DATE: June 14, 2024
TO: ALL PLAN HOLDERS OF RECORD
FROM: HUNTER SWATEK, AIA, PROJECT MANAGER
PROJECT: RAINBOW CITY RECREATION CENTER
GMC PROJECT NO. ABHM230021
RE: ADDENDUM NO. 2 AND
ACKNOWLEDGEMENT OF RECEIPT OF ADDENDUM NO. 2

ADDENDUM NUMBER 02

**PROJECT: RAINBOW CITY RECREATION CENTER
GM&C PROJECT NO. ABHM230021**

A2 REFLECTED CEILING PLAN - LEVEL 2
SCALE: 1/8" = 1'-0"

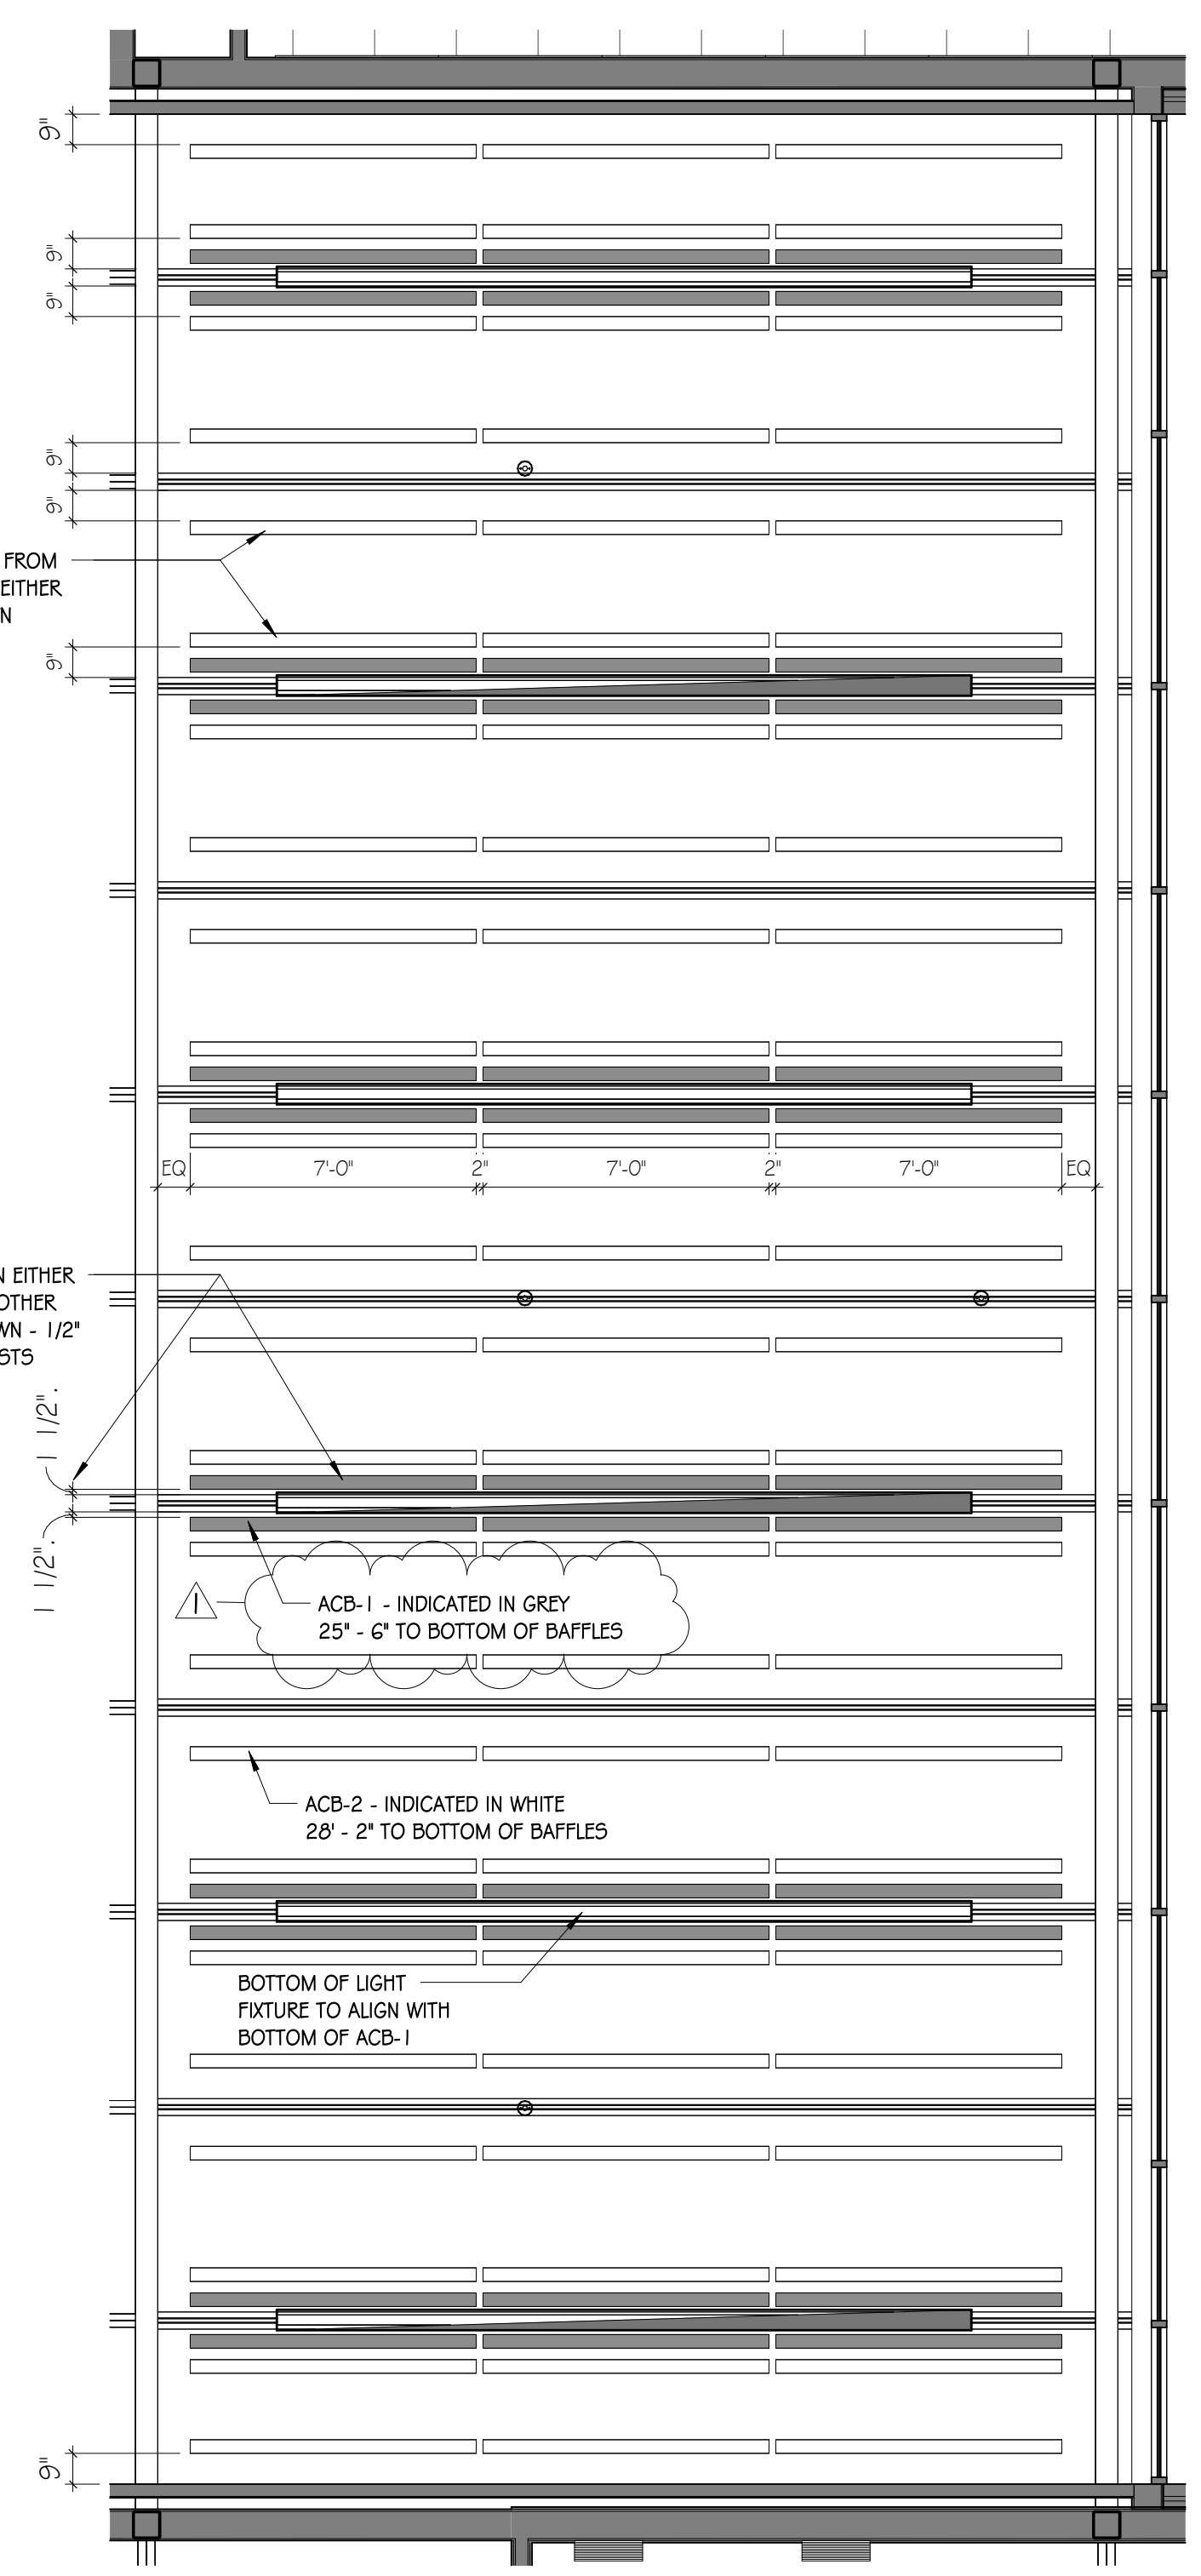
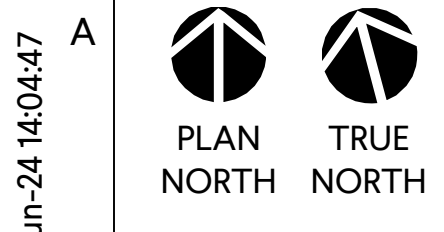
- A. **G1.01** Drawing Index Sheet
- B. **A2.02** RCP – Level 2
 - a. REVISED Baffle Height from Bottom of Baffle
- C. **A3.01** Roof Plan
 - a. ADDED Roof Overflow Drains

| Question | ADD # | Response |
|--|-------|---|
| A2.02 shows height to baffles to be 26"-4". Is this meant to be 26'-4"? | 2 | 25'- 6" to Bottom of Baffle, see revised A2.02 |
